**VILLAGE OF DOWNERS GROVE  
COUNCIL ACTION SUMMARY**

**AN ORDINANCE AUTHORIZING A SPECIAL  
USE FOR ST. ANDREW'S EPISCOPAL CHURCH TO PERMIT  
AN ADDITION TO THE EXISTING STRUCTURE**

PRELIMINARY PLANS-SPECIAL USE PERMIT FOR  
 ST. ANDREW'S EPISCOPAL CHURCH ADDITION,  
 DOWNERS GROVE, ILLINOIS

## PLANNING &amp; COMMUNITY DEVELOPMENT / STAFF DEVELOPMENT TEAM REPORT

AO.1

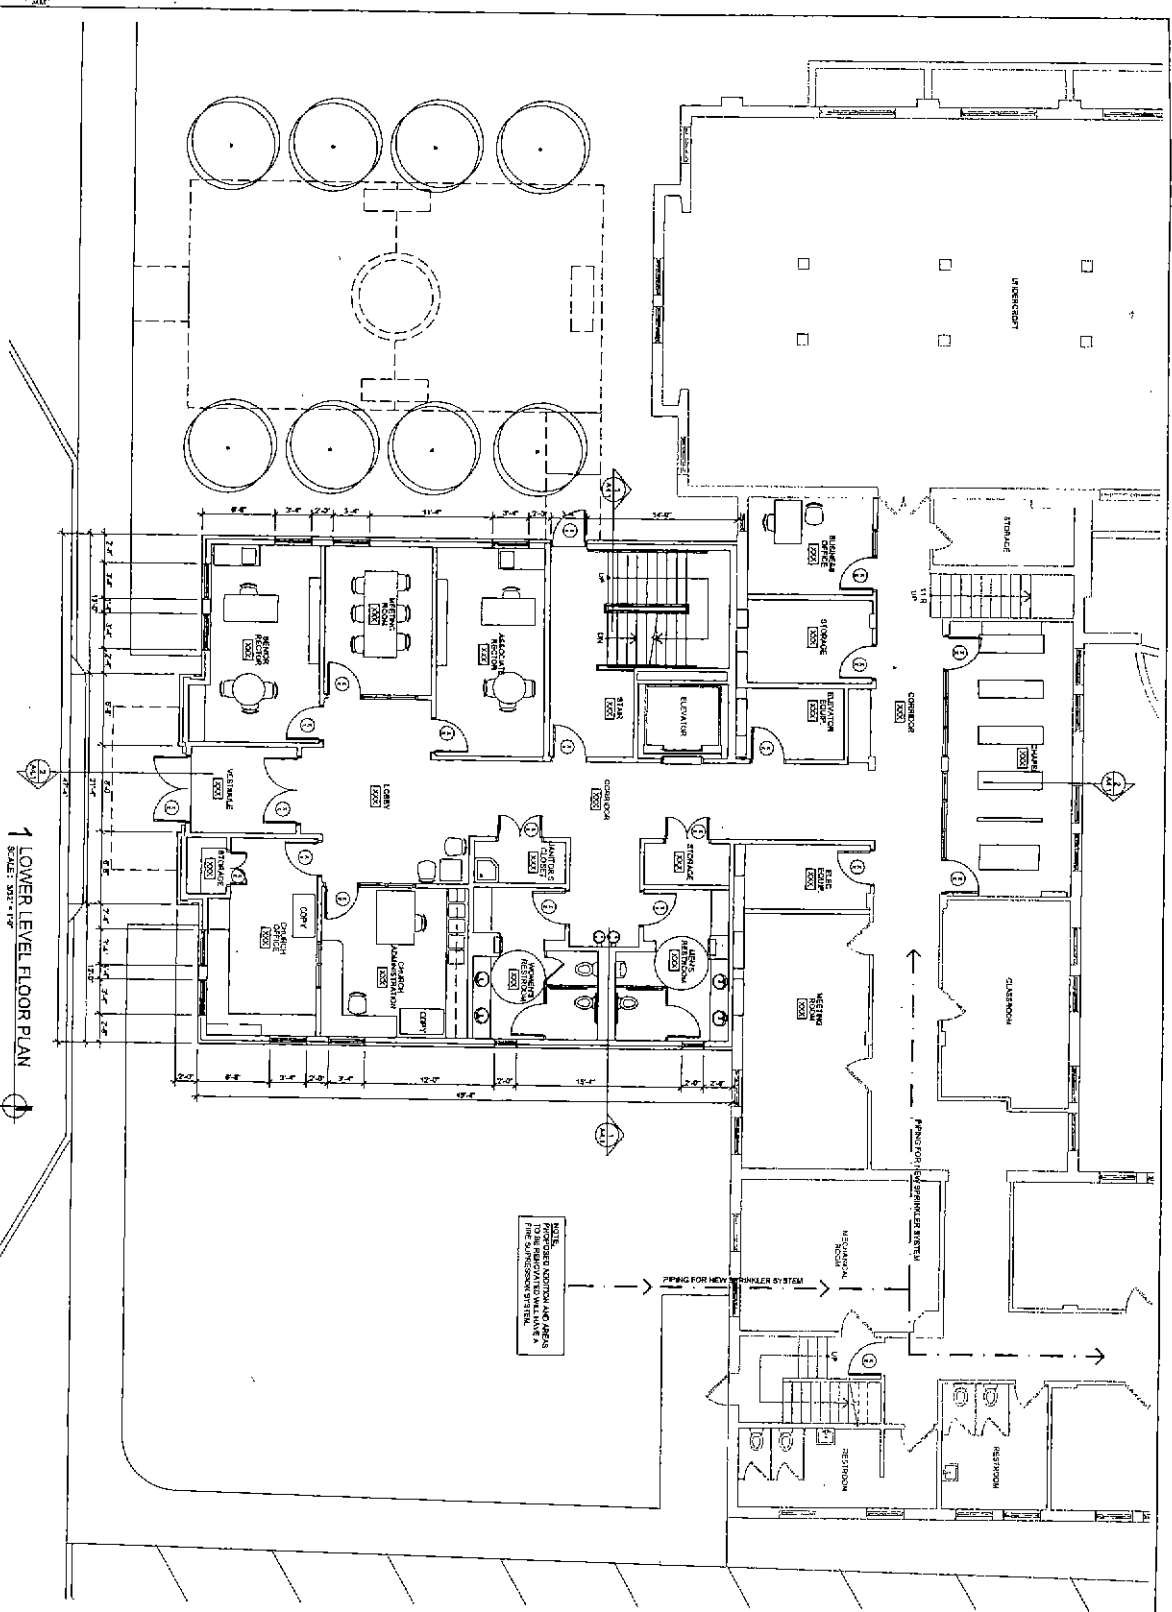
4. Provide a zoning analysis table indicating/summarizing compliance with requirements per Code based on the proposed addition (See attached sample).
5. Reconfiguration of the proposed parking space geometry may be required. Please note that the size of angled parking spaces is measured as the smallest rectangular area within the parking space. Section 28-1405(a), *Size of Parking Spaces*, requires parking spaces to be no less than 9 feet wide and 18.5 feet deep. The proposed new 60-degree spaces appear to be based on the geometry of the existing 60-degree spaces and measure 16 feet in depth (see attached diagram). Section 28-1405(a) also establishes minimum driveway aisle widths of no less than 18 feet for 60-degree parking spaces. Note that accessible spaces are to be provided in addition to the Code-calculated parking requirement. Also note that at least two spaces shown on the proposed plan are located in the required front yard adjacent to Saratoga.

4. A Zoning Analysis Table has been included (See Sheet A0.1) summarizing compliance with requirements per Code based on the proposed addition.
5. We indicated the revised dimensions of all the parking areas. Our parking space totals are now 36 spaces in addition to 2 accessible spaces for a total of 38 spaces. We have met the five foot set back requirement according to the special provision for parking in the front yard.

1 LOWER LEVEL FLOOR PLAN  
SCALE: 3/8" = 1'-0"

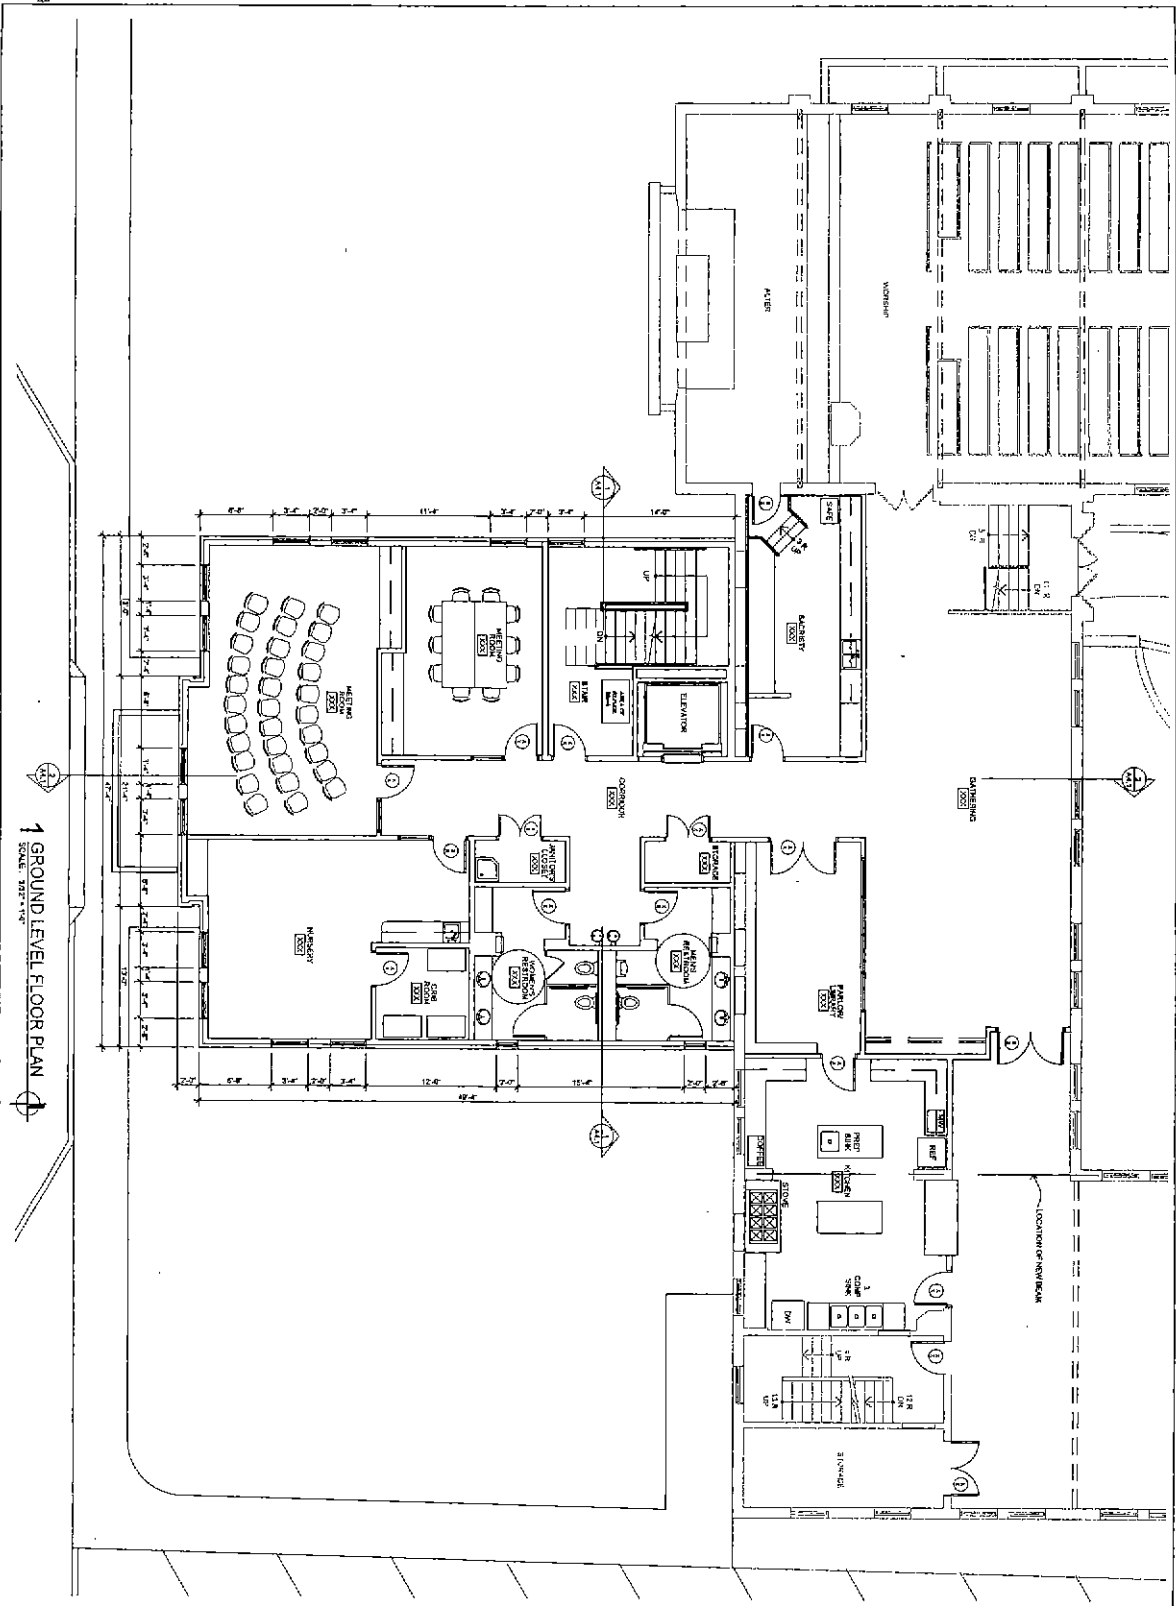
- Plans do indicate the installation of the Fire Sprinkler System in the new portion of the building.
- A letter of commitment was received by this office indicating; that the remainder of the structure will have the fire sprinkler system extended throughout, and it will be spread out over five years following completion of the addition.
- We are looking for a timeline outlining the completion of the sprinkler system in the remaining portions of the building. Basically we need to be able to attach tangible dates to the commitment letter. However the owner wants to break down the project into affordable phases is okay. We need to be able to show that there is progress on completion of the entire building. Indicating over the next five years it will be done is too vague.

8. A note indicating that the addition will be equipped with a fire sprinkler system has been added (See Sheet A1.1)
9. For Engineering responses see attached letter.

1 LANDSCAPE PLAN  
 SCALE: 1" = 30'

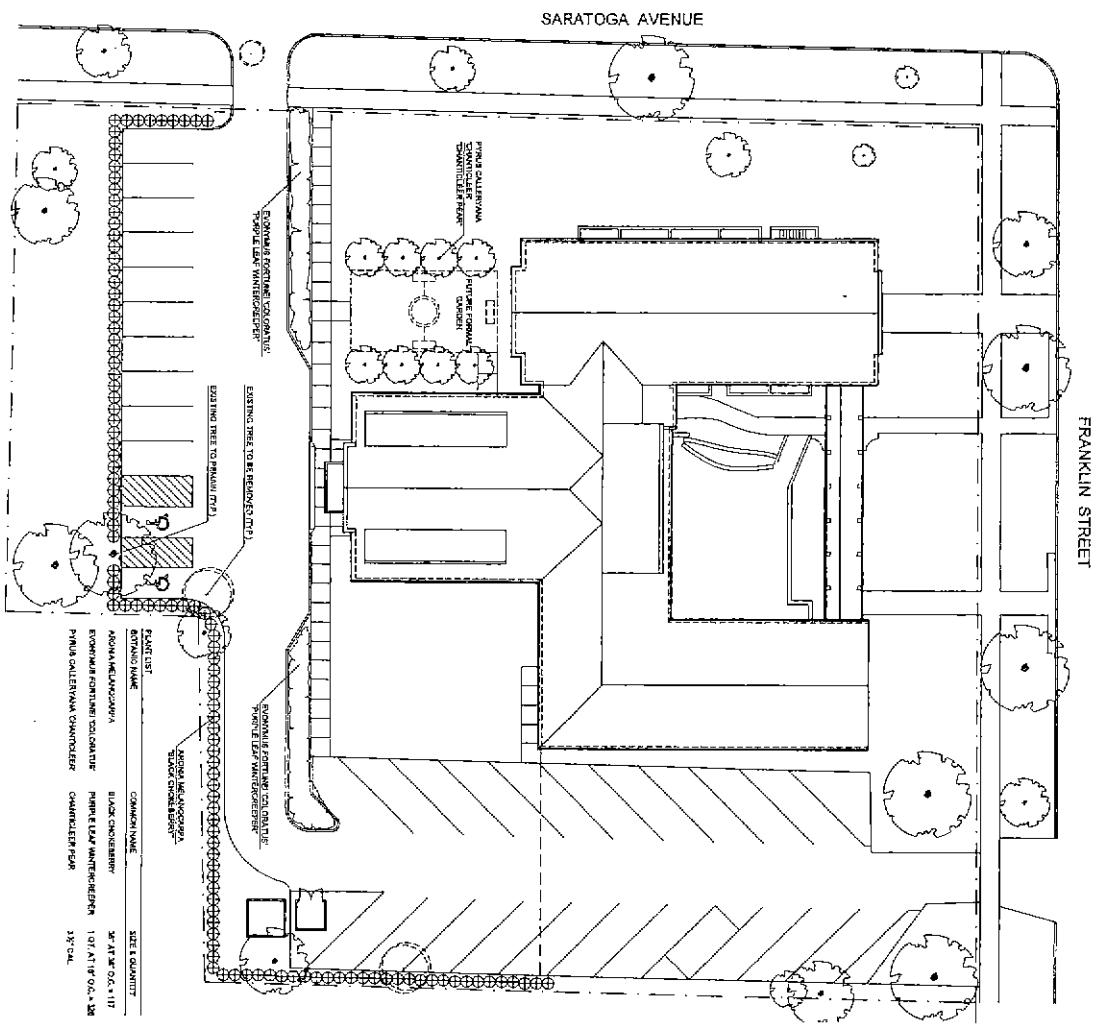
The proposed landscape plan has been reviewed by the Village Forester who has approved the landscape material and plant list on the proposed plans. The Forester noted that the small tree being removed in the Saratoga Avenue parkway will require compensation to the Village per Code. The Village will determine the value at the time of building permit.

6. The "One Way / Do not Enter" sign has been located on private property.
7. Screening has been provided for adjacent residentially zoned land per Code. (See Sheet L1.0).

PROPOSED PAVING, GRADING,  
& UTILITIES PLAN

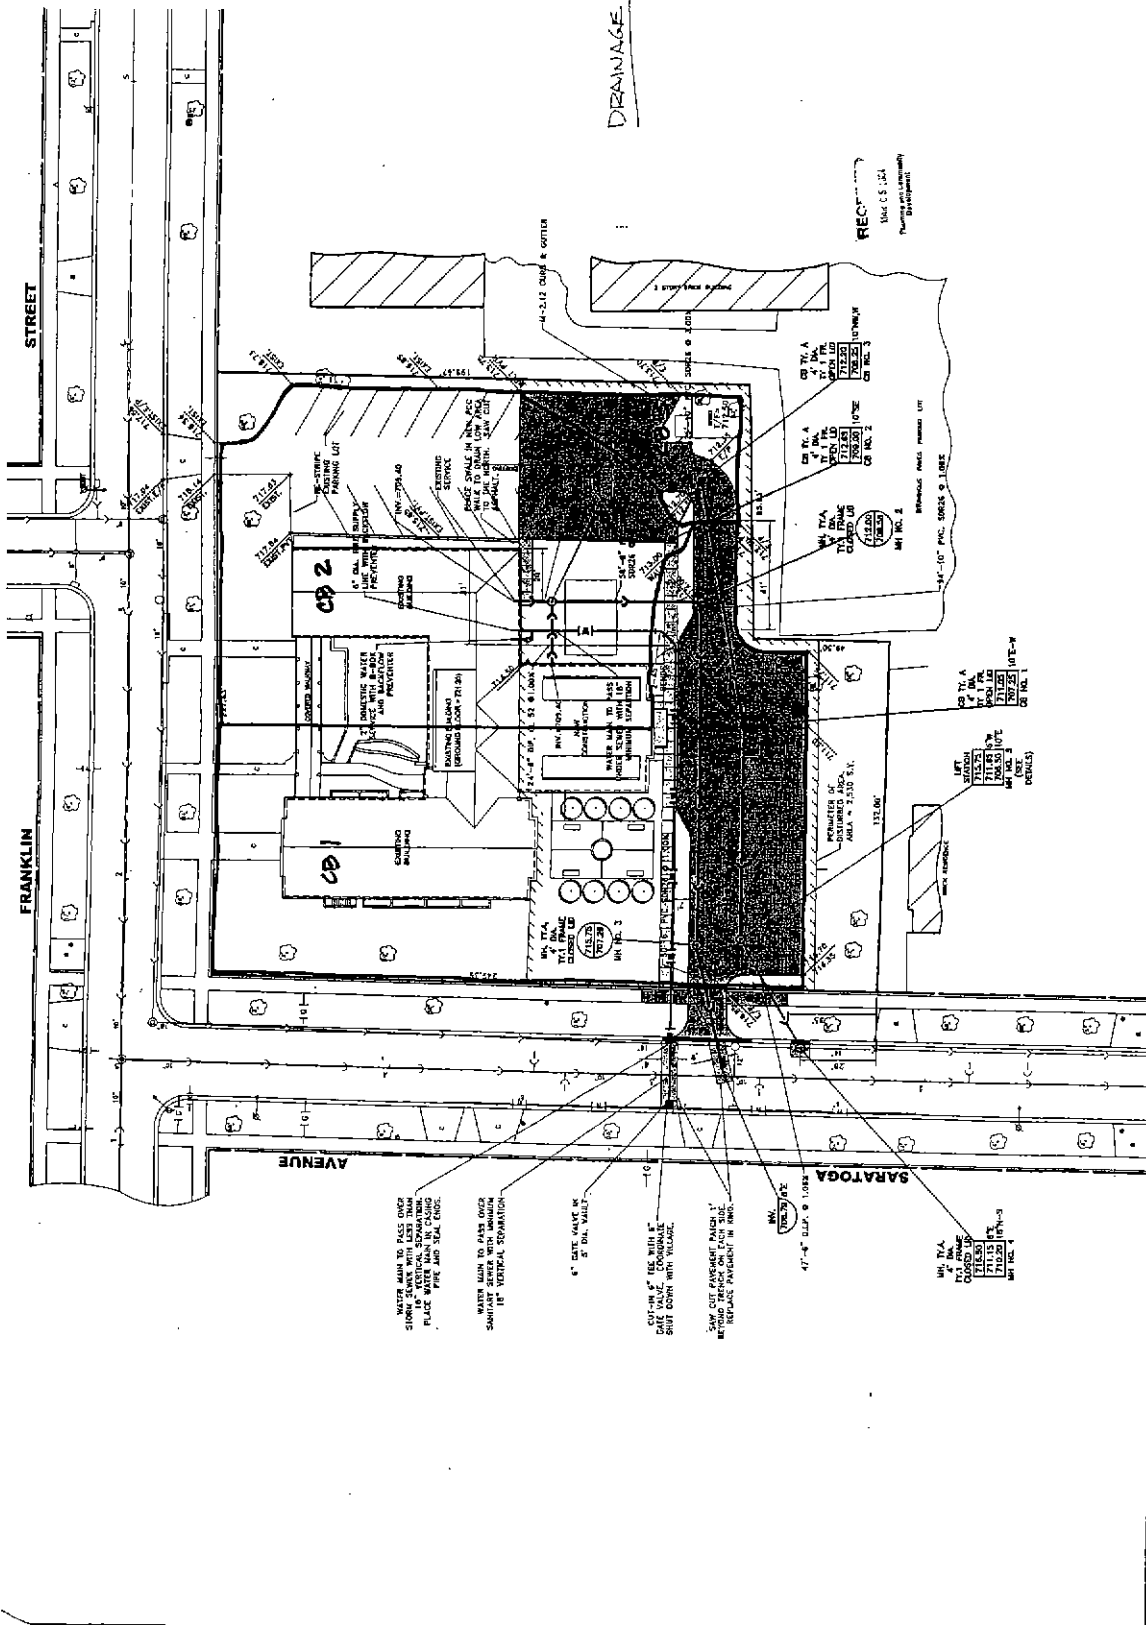
5. Change north-south street name label from Franklin to Saratoga.
6. The pavement slope in the handicap parking stall area exceed the ADA limit of 2.0%.

- The Street Name on the Utility drawing needs to be changed to Saratoga St.
- The Water main size on Saratoga is 6" and requires the Connection to be a cut in valve not a pressure tap.

- The Valve Must be a resilient Wedge Waterous or Mueller with Stainless steel bolts.
- The Valve must be in a 5' Vault Not 4' as noted on the plan.
- The 90 degree bend needs to be changed to two 45 degree bends.

1. The Street Name on the Utility drawing needs to be changed to Saratoga St.
2. The Water main size on Saratoga is 6" and requires the Connection to be a cut in valve not a pressure tap.

3. The Valve Must be a resilient Wedge Waterous or Mueller with Stainless steel bolts.
4. The Valve must be in a 5' Vault Not 4' as noted on the plan.
5. The 90 degree bend needs to be changed to two 45 degree bends.

1. The north-south street name has been changed to Saratoga.
2. A cut-in connection will be made to the existing 6" water main on Saratoga.
3. The required valve has been noted on the plans.
4. The vault diameter has been changed to 5' diameter.
5. Two - 45 degree bends have been substituted for the single 90 degree bend.
6. A note has been added requiring retainer glands on all fittings
7. The separation between water main and sewer is at least 10' horizontally.
8. The new domestic water service will be tapped off of the 6" main outside and will have its own B-Box.
9. A section labeled Water Main General Notes has been added to address the rest of the comments.
